CERTIFICATE OF APPROPRIATENESS

Property: 509 Columbia Street, Lot 1, Block 1, Houston Heights Neighborhood Subdivision. The property includes a non-historic 2,135 square foot, two-story wood single-family residence and detached garage situated on a 3,300 square foot (25' x 132') interior lot.

Proposal: Alteration: Rear Detached Garage Apartment Atop Existing Garage

<p>Recommendation: Approval with conditions: Inset Garage Apartment 3" on the south side to meet the Houston Heights Design Guidelines cumulative 6' and remove proposed eaves on North and South elevation.</p>
--

Side Wall Length and Insets (Addition and New Construction)

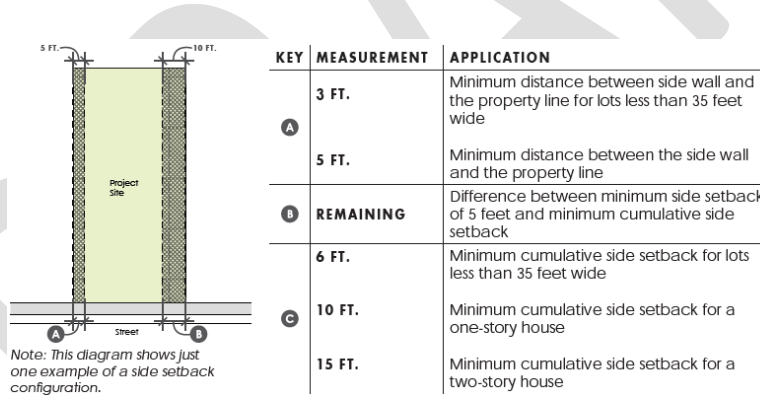
Side Wall Length: 25' 1-1/2"

Inset Length: 0' ****Inset not needed as side wall length is less than 40' for a 2-story building****

Side Setbacks (Addition and New Construction)

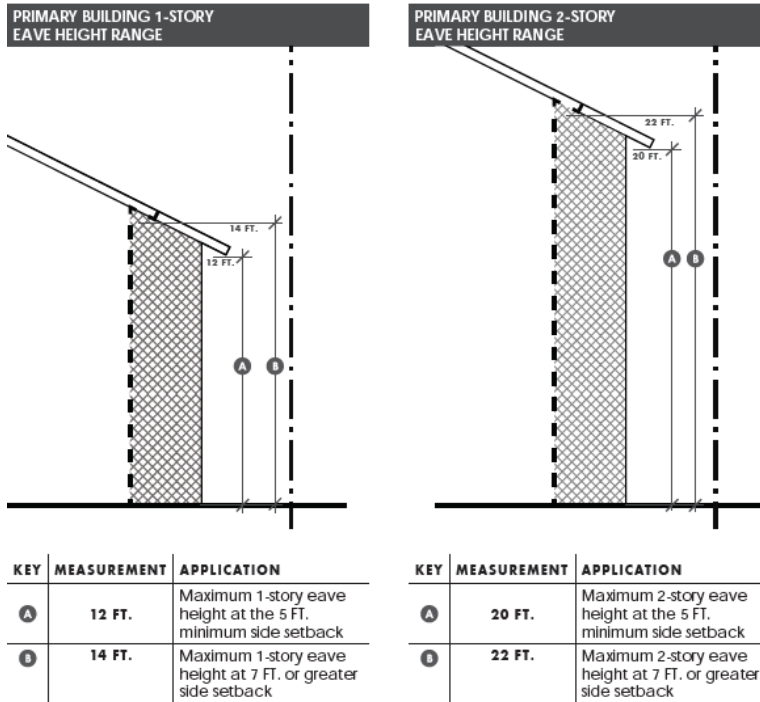
Proposed North side setback (1): 3' 0"

Proposed South side setback (2): 2' 9" ****Does not meet 3' minimum distance between side wall and the property line for lots less than 35' wide****

Cumulative side setback: 5' 9" ****Does not meet 6' minimum cumulative side setback for lots less than 35' wide****

Rear Setbacks (Addition and New Construction)

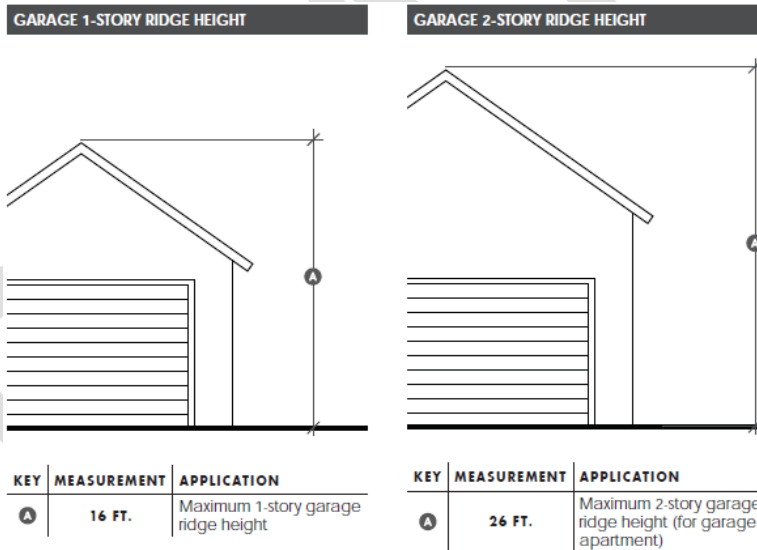
Proposed rear setback: 5' 7-1/6" **This meets the minimum 20' of clearance **
